“City of Havelock
Pineview Lift Station Repair”
Addendum 1
June 19, 2020

SKETCH "NOT TO SCALE"
EXACT LOCATION OF NEW YARD
HYDRANT WILL BE PROVIDED BY
CITY OF HAVELOCK.

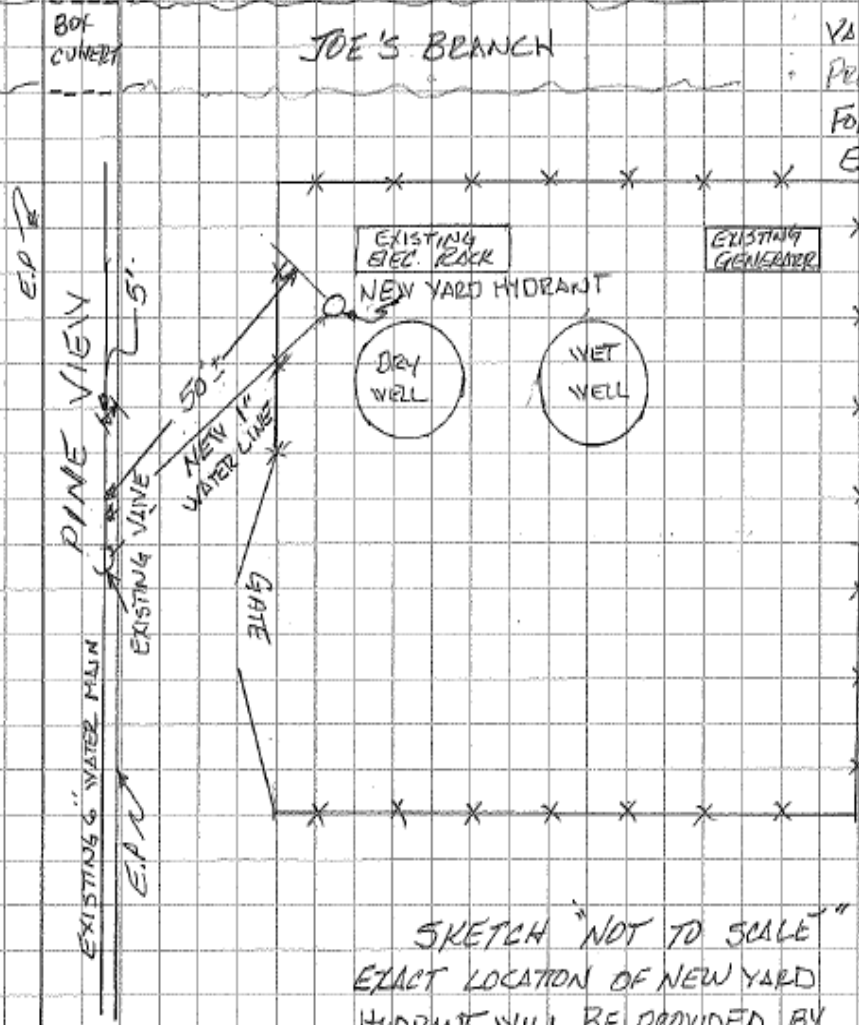
13. Can a sketch be provided on the location of the wet tap and the proposed yard hydrant?

14. What is the approximate size of the main that will be tapped?

See drawing below.

See drawing below.

1. EXACT DEPTH OF EXISTING
6" WATER MAIN UNKNOWN.
FOR BIDDING PURPOSES
ESTIMATE 3' TO 5' DEPTH

2. EXACT LOCATION OF NEW
YARD HYDRANT WILL BE
PROVIDED BY CITY OF HAVELOCK
FOR BIDDING PURPOSES
ESTIMATE 50' OF NEW
LINE.
